## **Exhibit 4: Marquis Theater**

**Exh. 4B Architectural Modifications to Marquis Theater**

### **Exhibit 4C: Seating**

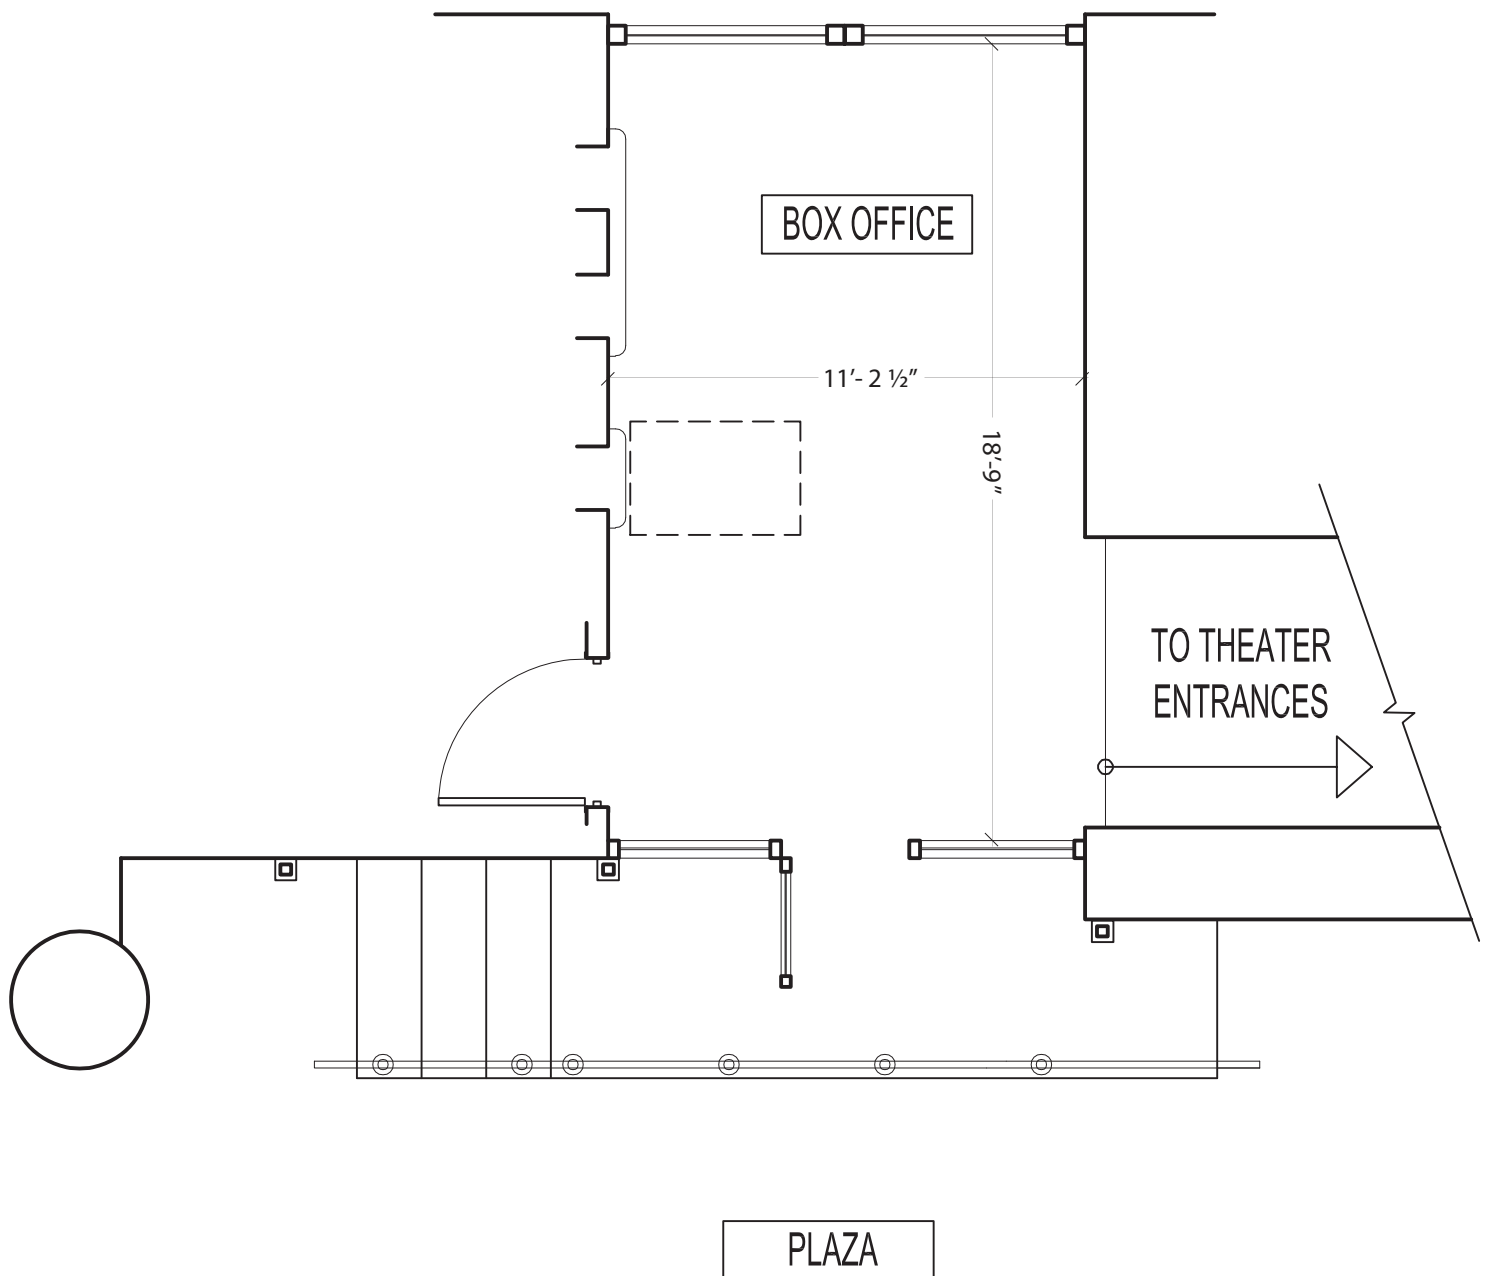
1. Nederlander shall maintain the eight existing wheelchair and companion seating locations on the Orchestra level: at Y2, Y3, Y4, Y5, Y102, Y103, Y120, and Y121, with Y1, Y2, Y7, Y8, Y101, Y104, Y119, and Y125 being companion seating locations.
2. Nederlander shall add two wheelchair seating locations on the Orchestra level at Y14/Y12/Z8/Z6 and Y13/Y11/Z5/Z7, with Y10 and Y9 being companion seating locations.

3. Nederlander shall add sixteen new aisle transfer seats on the Orchestra Level at K2, F18, S28, T2, A2, P125, P101, T1, S27, K1, F17, A1 and on the Mezzanine Level at K34, L2, L1 and K33.

**4. MARQUIS THEATER**  
**BOX OFFICE PLAN**  
**EXISTING CONDITIONS**

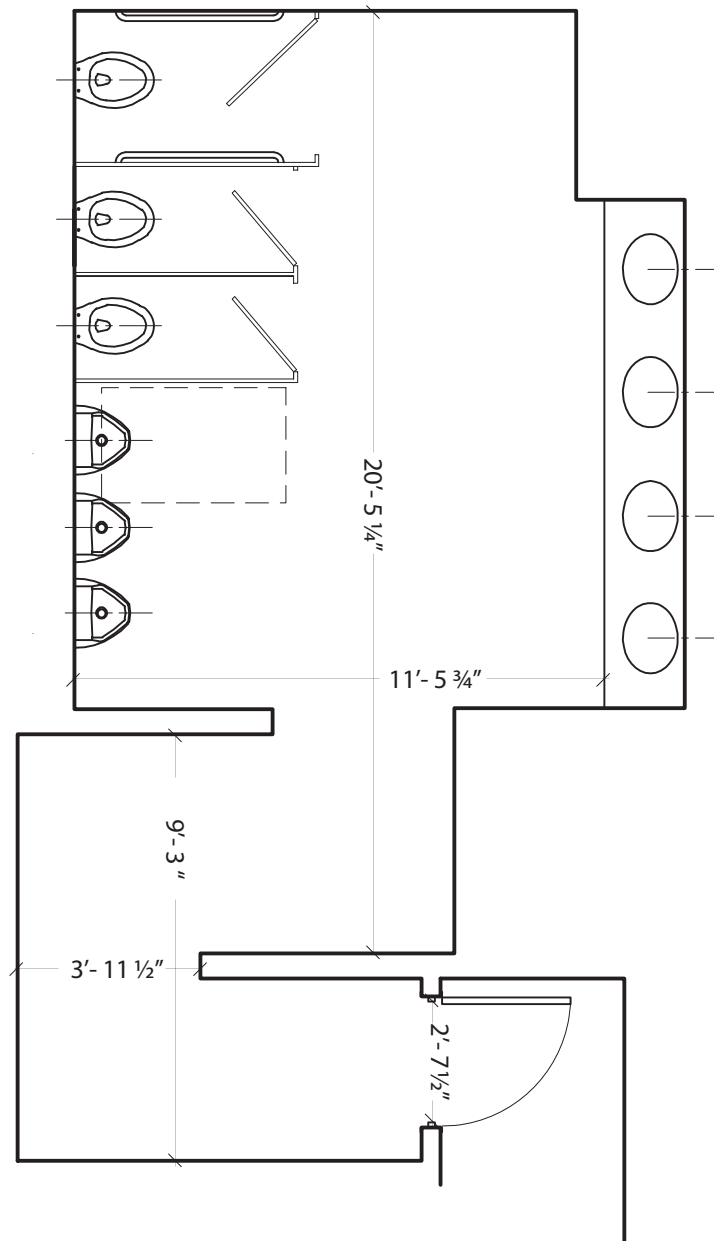
11	Ticket Office	Sales, service or information counter higher than 36" AFF at cash register(s) for sales or distribution of goods or services to the public. Ticket counters are at 42½" at AFF.	Alter at least 1 counter of each type such that a section at least 36" long is not higher than 36" AFF, and is on an accessible route. A writing shelf attached to the front of the counter or an auxiliary counter may be acceptable.	7.2(2) 4.3	<b>Defendant will include accessible sections in operating concession counter.</b>
12	Ticket Office	No assistive listening system was found during survey and there was no signage at the ticket office or other apparent location notifying patrons of the availability of an assistive listening system.	Install ALS system with the required number of receivers and signage incorporating the International Symbol of Access for Hearing Loss at the ticket office(s) or other apparent location(s) notifying patrons of the availability of an assistive listening system. Sign should state "Assistive Listening System Available".	4.1.3(19)b 4.33 4.30, Fig. 43(d)	<b>Defendant has provided ALS and will continue to do so.</b>
